**EPA Request for Information
Underground Injection Control (UIC) Permit Application
Class I Non-Hazardous Wells
Elk Hills Power – R9UIC-CA1-FY10-2R**

Response to Elk Hills Permit Application Questions and Comments (12-14-2011)

Wells in Area of Review

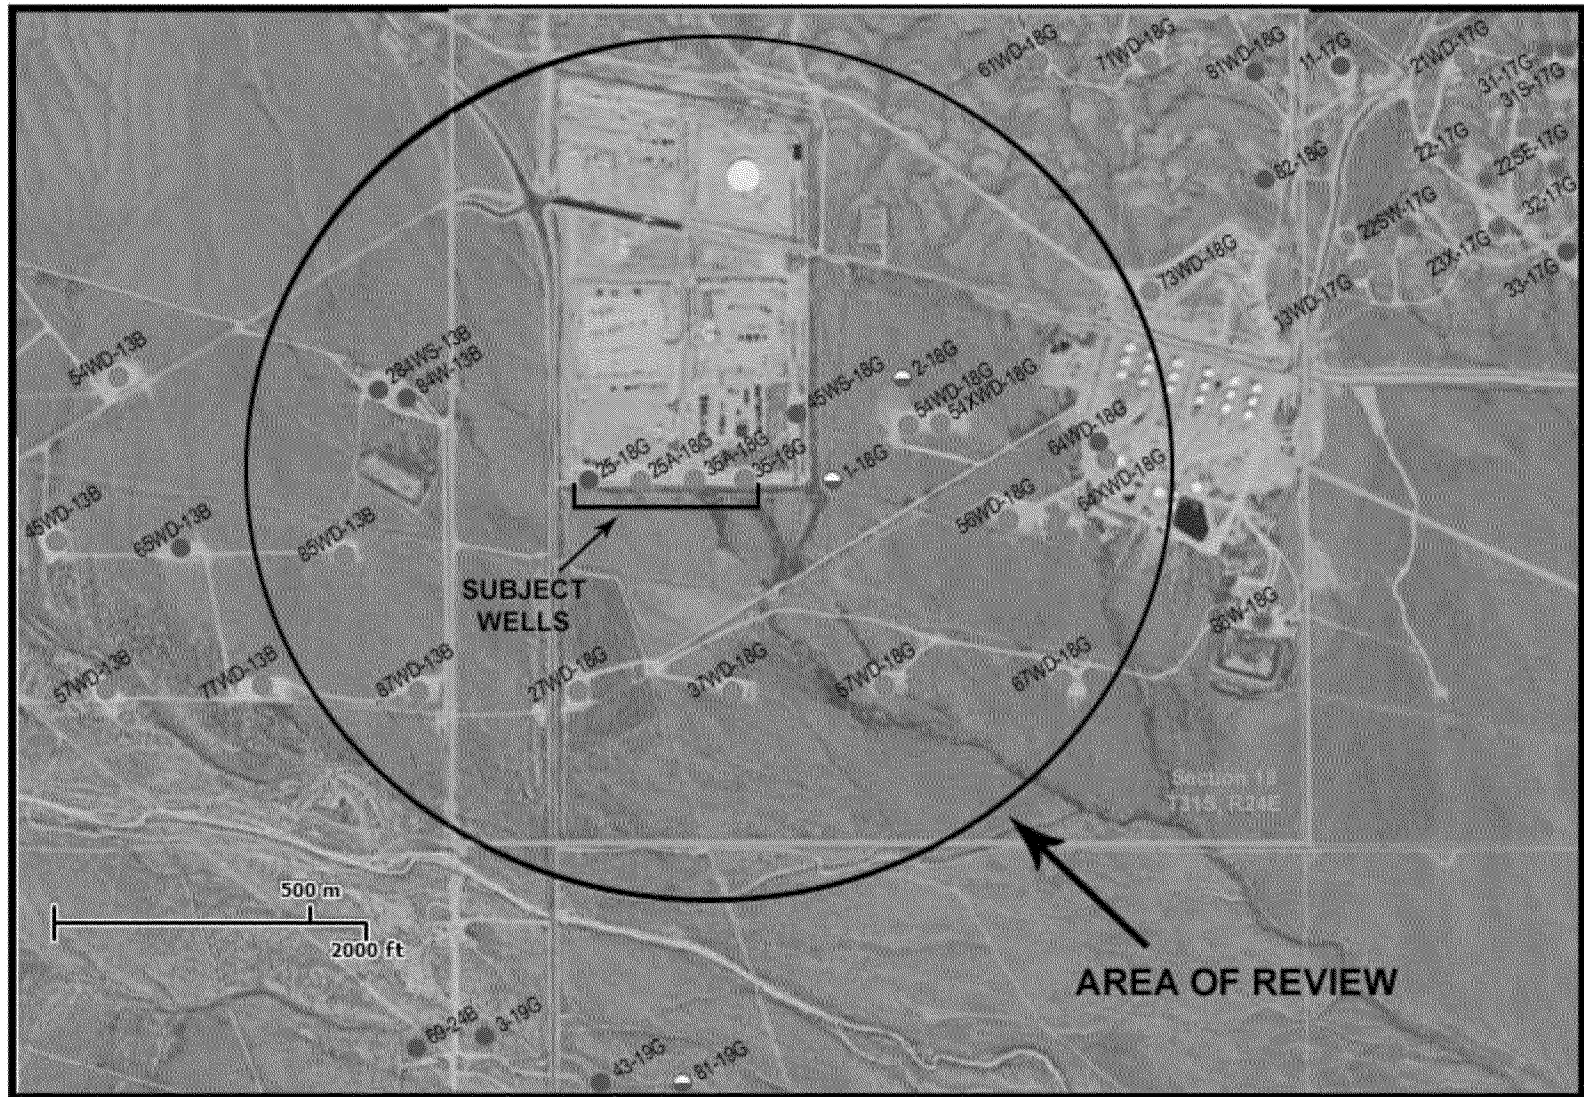
2. Map symbols for Exhibit B-3 are very hard to read. Please provide a better map with more color variety and greater shape difference between symbol types to allow better identification of well types. It is not clear why some symbols are red and some are black. Please revise the legend to explain the reason for the two colors.

*Response: **EXHIBIT B-3** is revised to be more legible and in a larger size. The revised exhibit provides the requested color and shape variety changes to allow for better identification of well types.*

Structure of the Base Tulare Clay and Locations of Geologic Cross Sections A-A' and B-B'

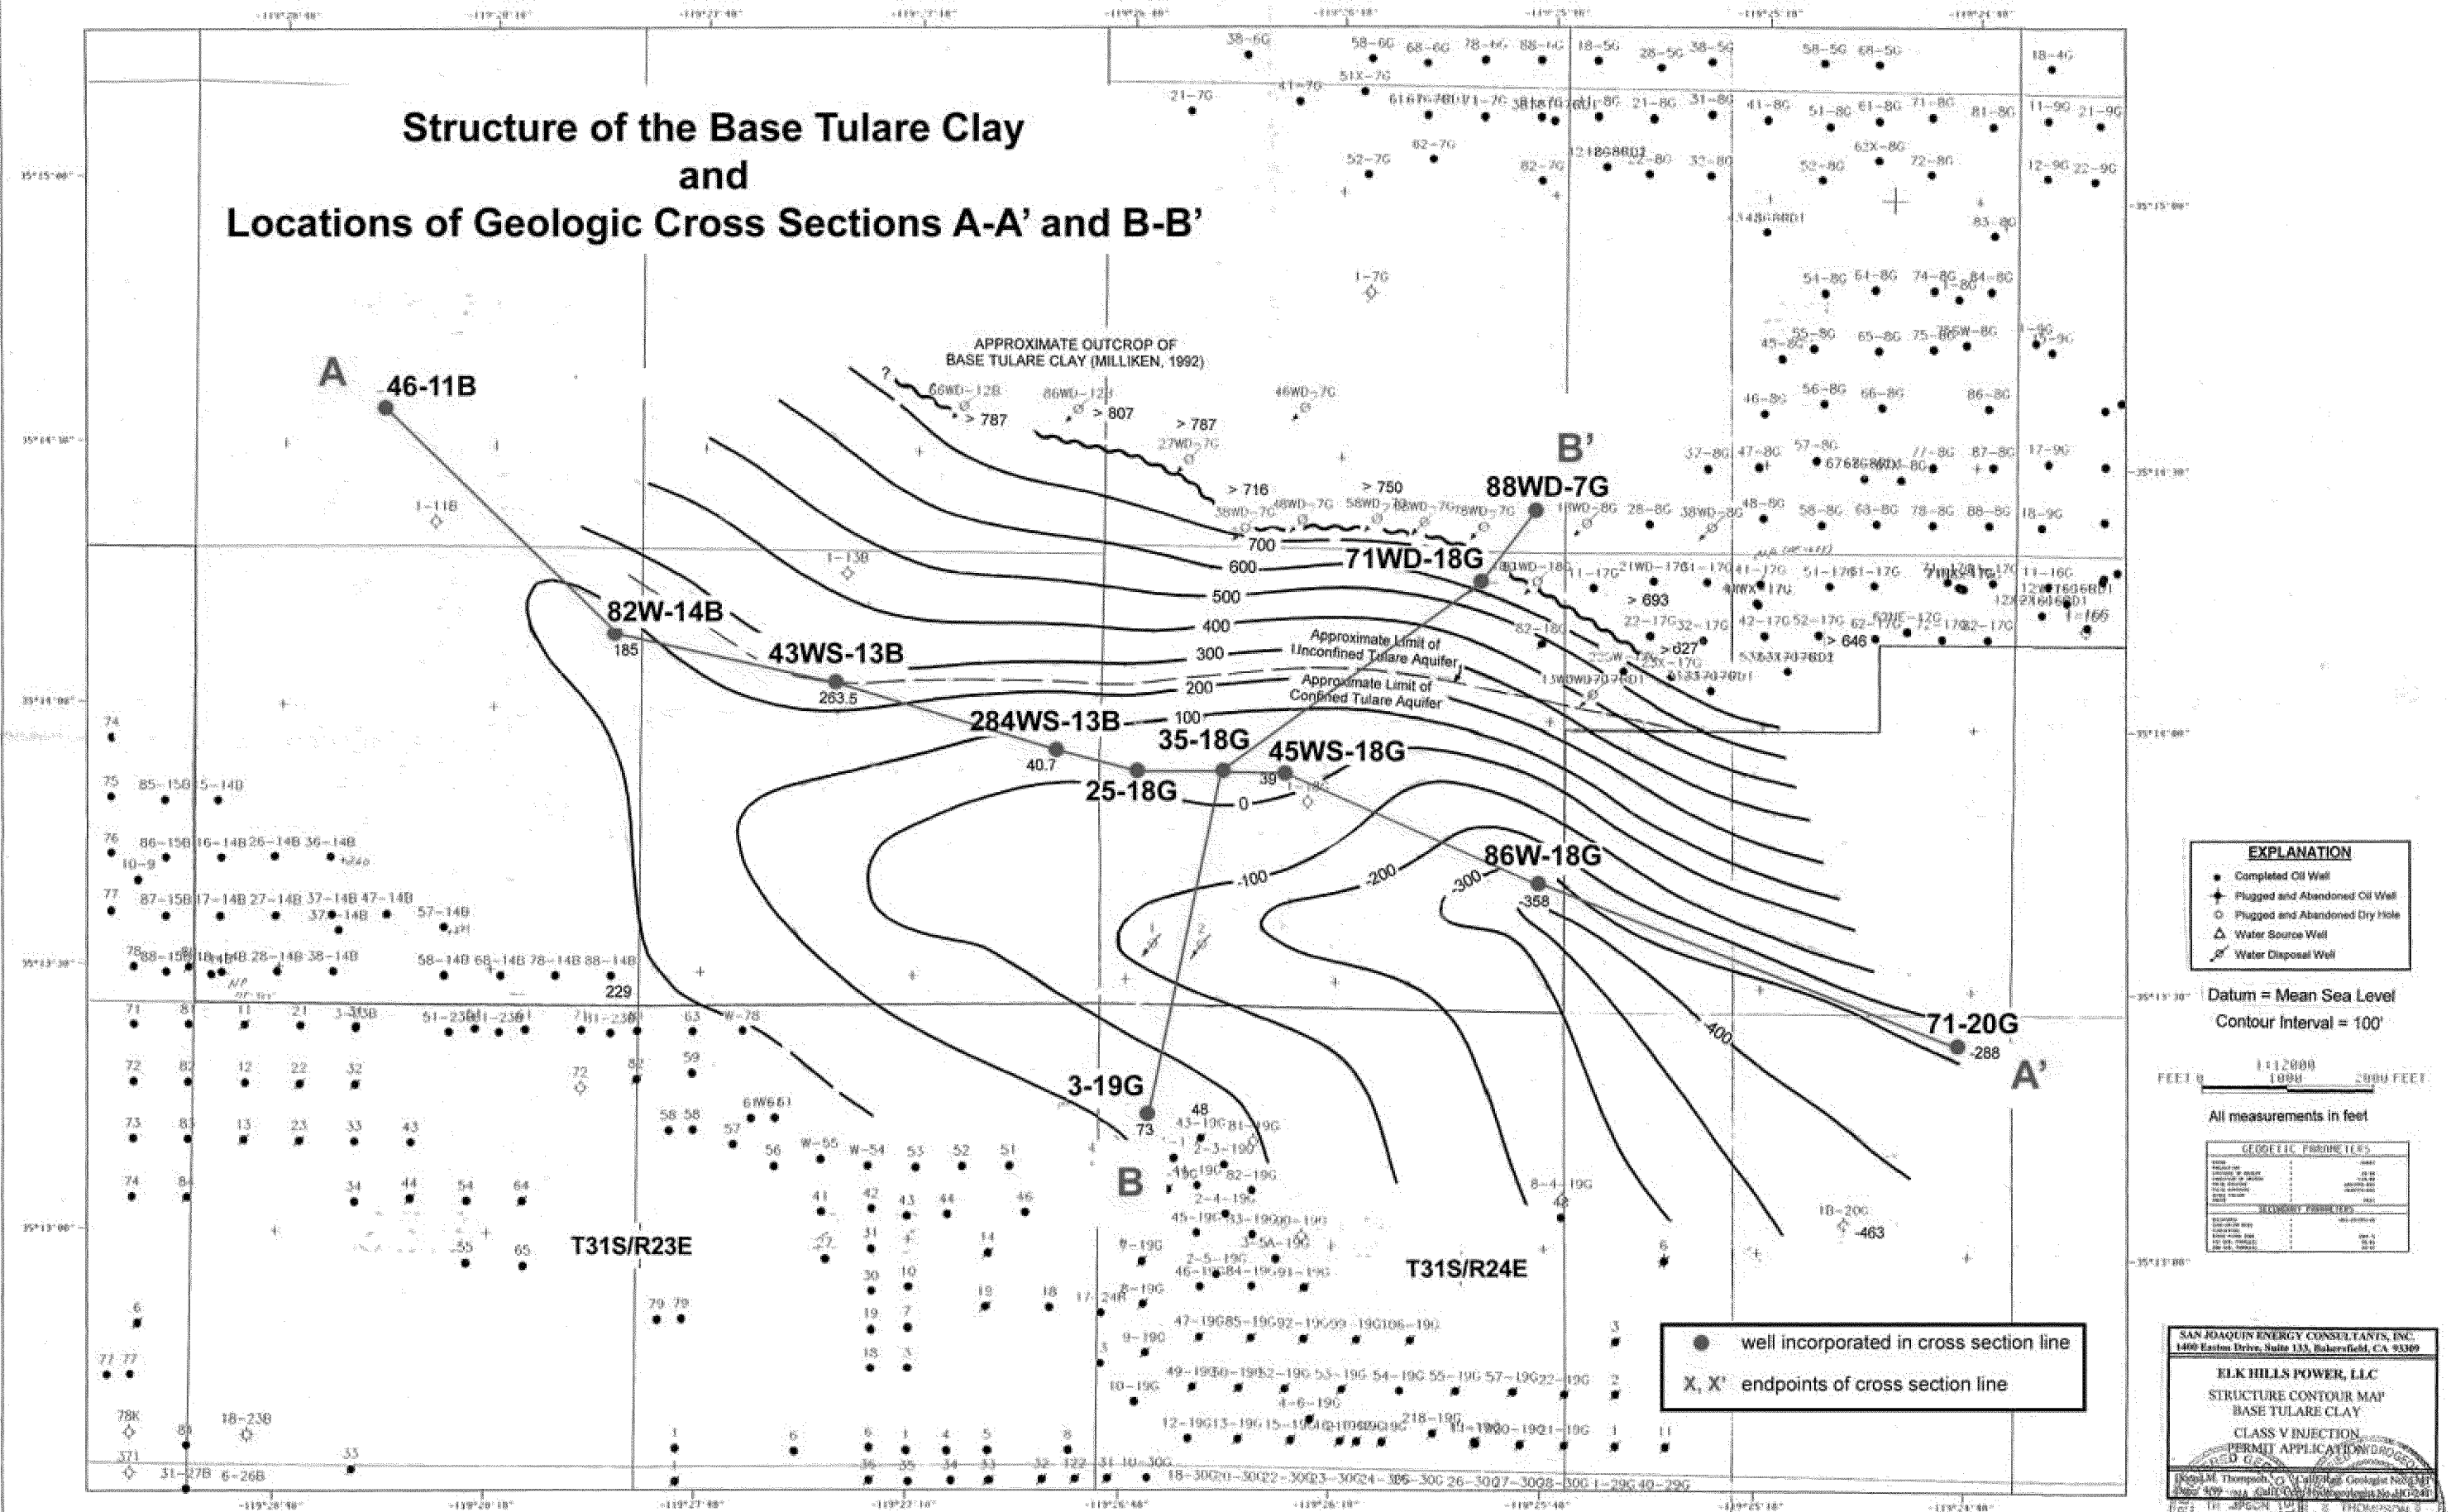
3. The geological cross sections (F-8 and F-9) were not updated since the original permit application. In EPA's March 2, 2011 Technical Review Letter (EPA letter), we specifically requested that the geological cross sections be re-drawn to include data obtained from the permitted wells (25-18G, 25A-18G, 35-18G and 35A-18G) constructed under the existing permit. The submitted geological cross sections do not include the permitted wells and data obtained from them. Also, all wells included in the cross sections should be legibly labeled with the well identification on both the cross sectional maps (Exhibit f-8) and the topographical map of the two cross sections (Exhibit F-7). Data from all four injection wells could be included in Cross Section A - A', since this cross section follows a similar west to east direction as the line of wells 25-18G, 25A-18G, 35-18G and 35A-18G. Please redraw A - A' to include these wells or explain why they are not included. Cross Section B - B' is oriented in an approximate north to south direction. Because of its perpendicular orientation to A - A', it may be difficult to include data from all four injection wells. Please redraw B - B' to include as many of the four injection wells as possible or provide explanation as to why they are not included.

The topographical map, EXHIBIT F-7, is revised to legibly label the path and well identification of the two cross-sections.
